Preliminary Consultation
HISTORIC PRESERVATION COMMISSION STAFF REPORT

Address: 7323 Takoma Ave., Takoma Park **Meeting Date:** 8/15/18

Review: Preliminary Consultation **Public Notice:** 8/1/18

Proposal: Rear Addition Construction

7323 Takoma Avenue
Proposed Site Plan with Sunroom Addition
1" = 20-0"

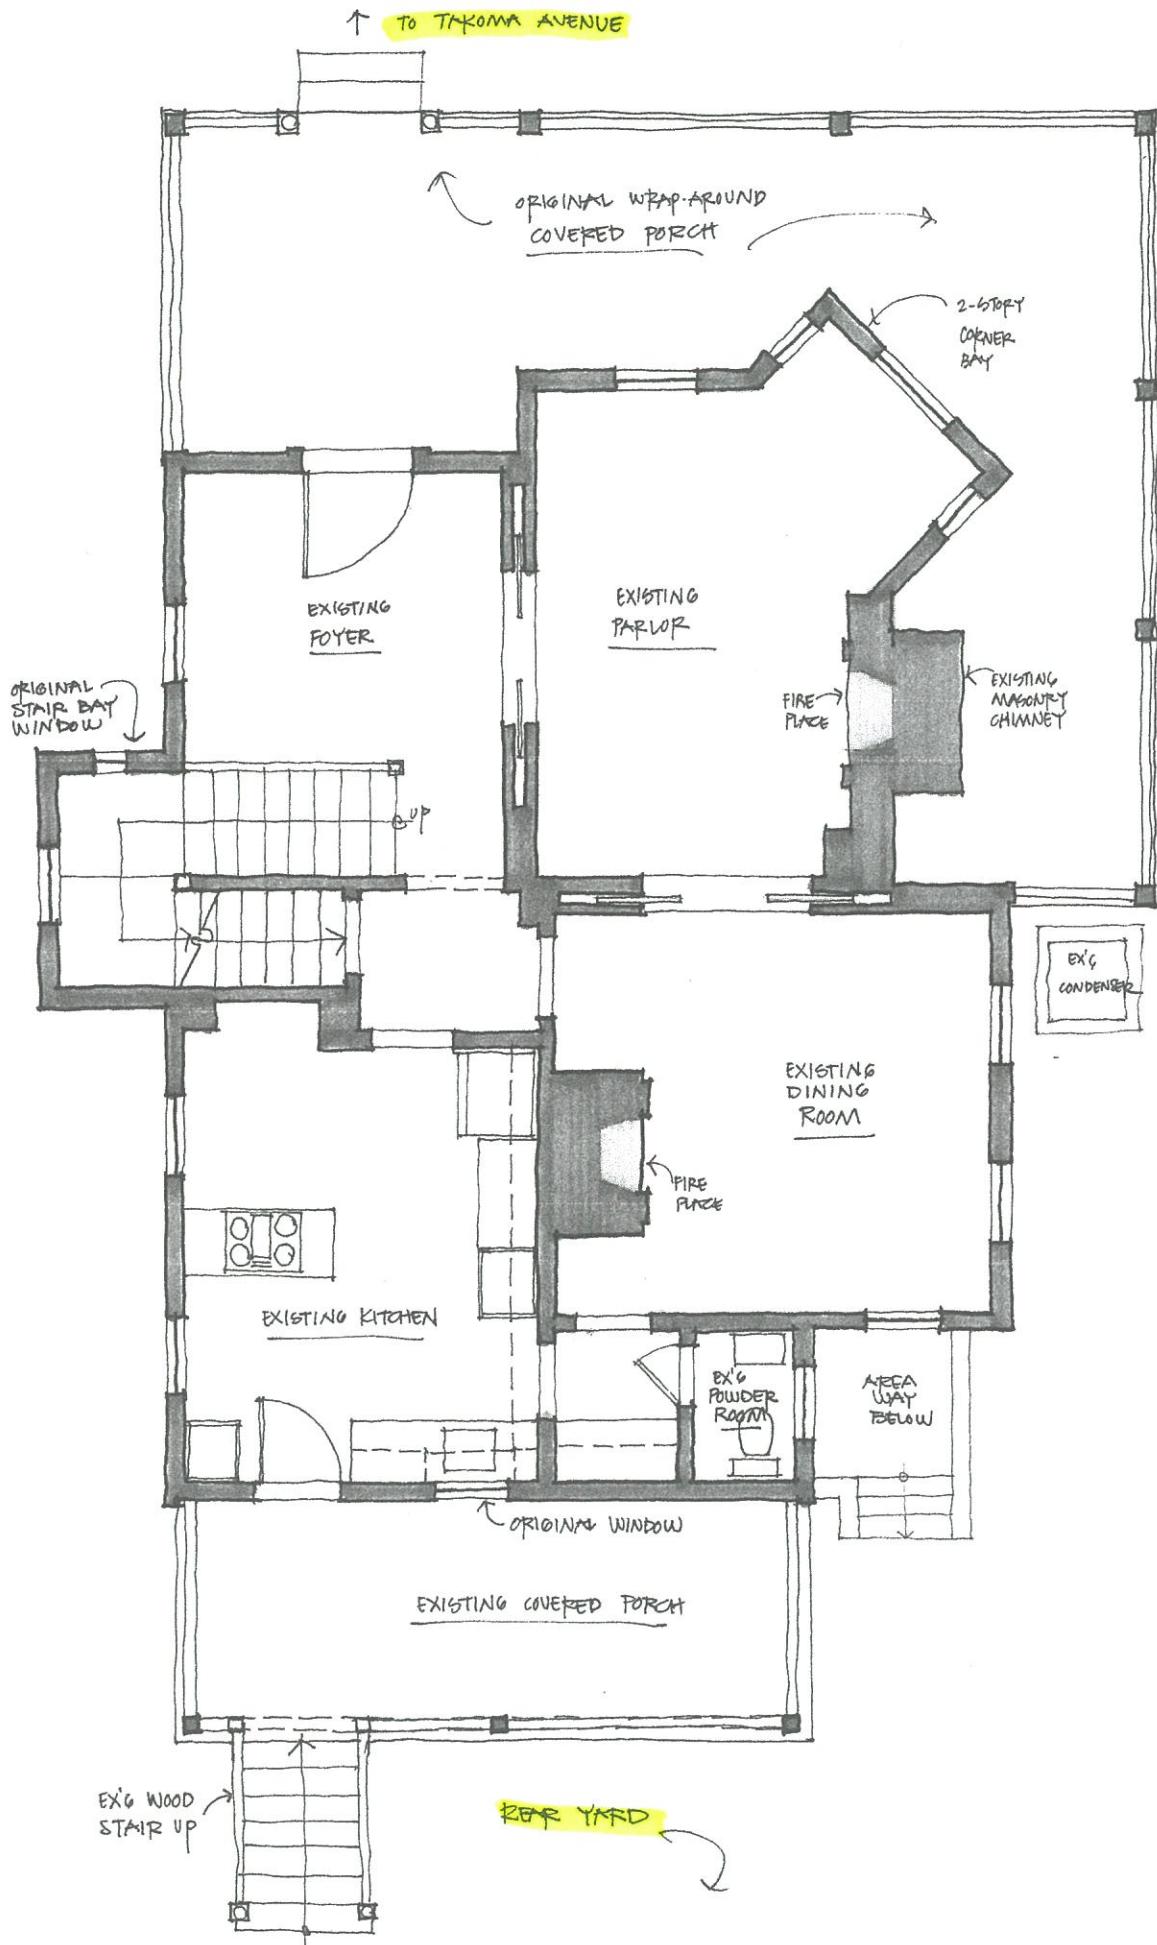
There are two additional elements that warrant discussion as part of this preliminary consultation. First, is the proposal to install a new HVAC condenser to the north of the proposed addition. The design presented does not include any screening and Staff would like to solicit input from the HPC regarding the placement and screening or lack thereof. While Staff does not find the proposed location will detract from the historic character, alternative locations may be considered including under the proposed new construction. Second, the floorplans show there will be a wood burning stove in the new construction. One of the elevation drawings shows the vent stack projecting above the shed roof. Staff encourages all future drawings to include this vent to allow for more thorough evaluation. Even without a sightline study, Staff does not believe that this element will be visible from the public right-of-way but encourages the applicant to include that information in any future submissions.

SPALDING ADDITION · EAST ELEVATION · SCHEME C

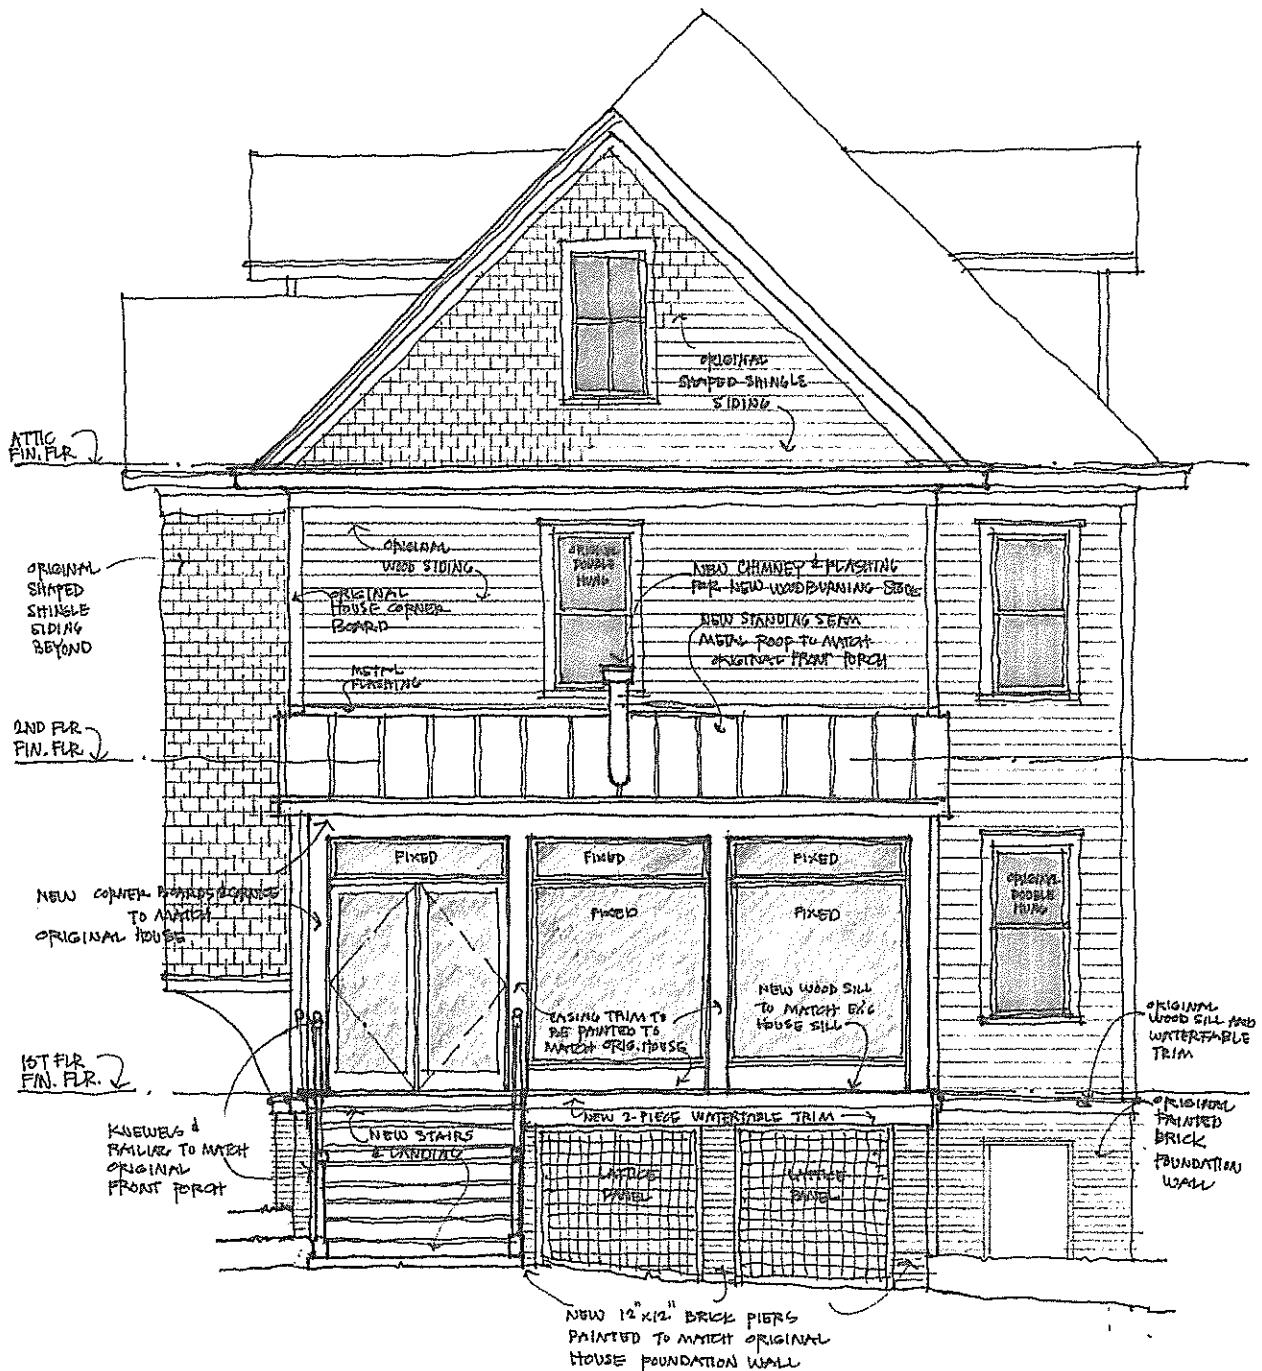
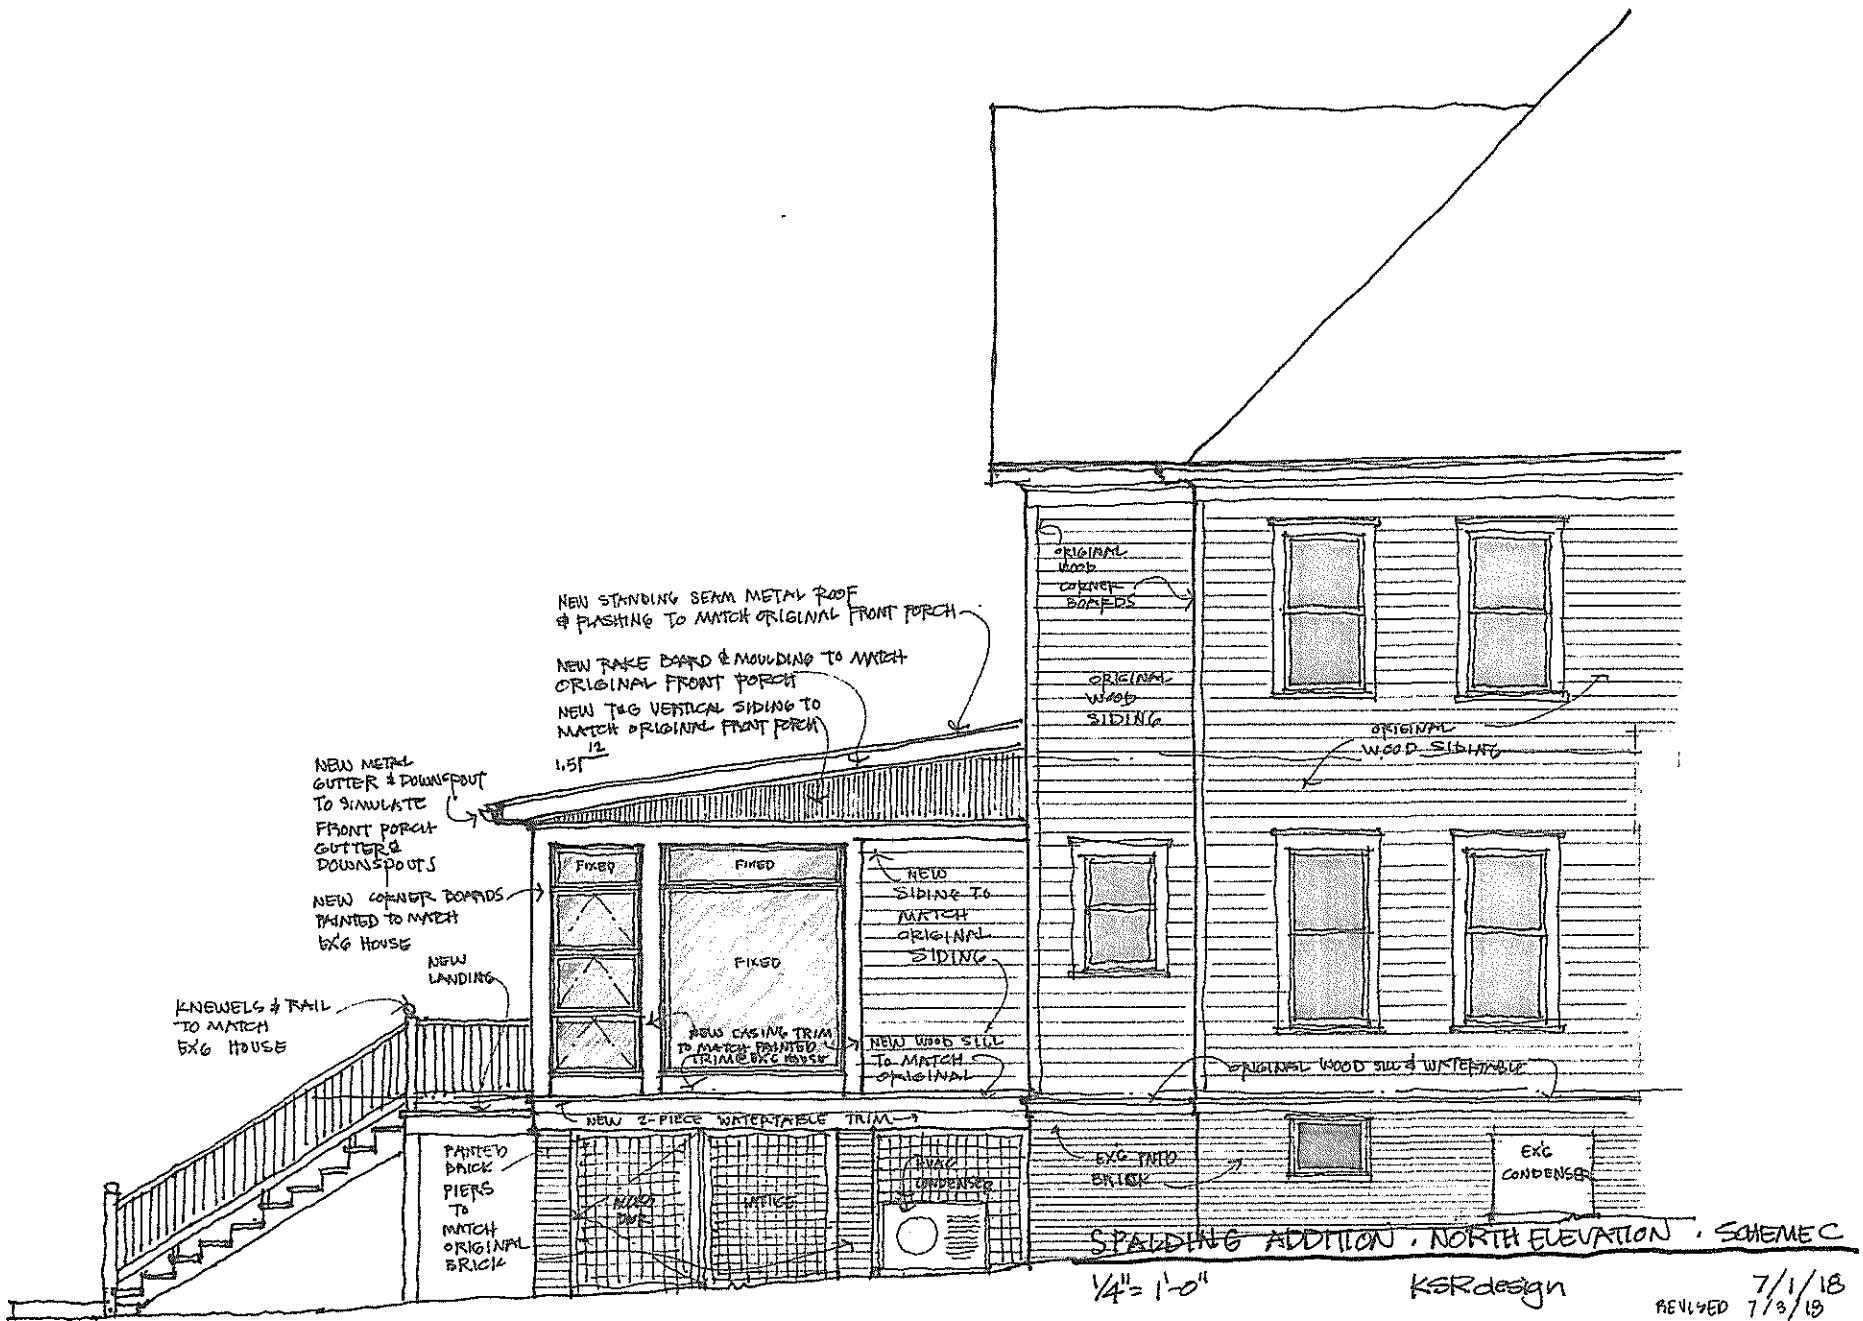
The applicant proposes to construct a 16' × 20', wood-framed, covered "four season room" to the rear in place of the existing porch. The proposed room will be inset from the historic wall planes by approximately 8" (eight inches) on either side. The room will be supported by a brick

pier foundation with wood lattice panels filling in the gaps. The drawings submitted with this prelim state that they will match the historic brick foundation. The proposed standing seam metal porch roof will match the front porch roofing. The vertical siding under the shed roof will also match the detail found in the front porch. The applicant proposes to use large fixed windows and transoms to fill in the openings. The exceptions are in the paired French doors at the rear, a pair of casement windows on the south elevation, and a series of awning windows on the north side with a section of clapboard siding to match the historic house. To the rear of the addition the applicant proposes constructing a new wood landing with a wood staircase.

Staff finds that generally the design and materials proposed comply with the *Guidelines* and Chapter 24A. The brick and wood are consistent with what is found elsewhere on the house. It is Staff's belief that the chosen placement, at the rear, will have the least impact on the highly decorative elevations of the house and will impact the least detailed elevation. Additionally, Staff finds that the proposed wall inset is less than what the HPC typically requires in rear additions. Staff finds the placement acceptable for two reasons; first, the setback is generally consistent with the existing porch; and second, due to the irregular house form, this new room will be partially obscured by other house projections. When viewed from the southeast the projecting stair bay will block some of the view; and when viewed from the northeast, the new construction would be obscured by the dining room. Based on observations at a site visit Staff believes that the rear corners of this addition would be partially visible from the public right-of-way.

Staff is most concerned about the amount of glazing and whether the HPC finds that the large fixed windows are out of character with the house and surrounding district. If this proposal were submitted as a screened-in porch, Staff has little doubt that there would be overwhelming support the proposal as not detracting from the historic character of the resource. However, Staff finds that the large amount of glazing is not in keeping with the character with the historic house (Standard 9) and recommends the amount of glazing be reduced prior to the HAWP submission. Staff would be more supportive of this proposal if there was a bulkhead or knee wall on the lower portion that would reduce the overall amount of glazing. This feature could draw from the materials used on the front porch. Staff request the HPC to provide comments on the appropriateness of the glazing and recommended revisions to the design and materials.
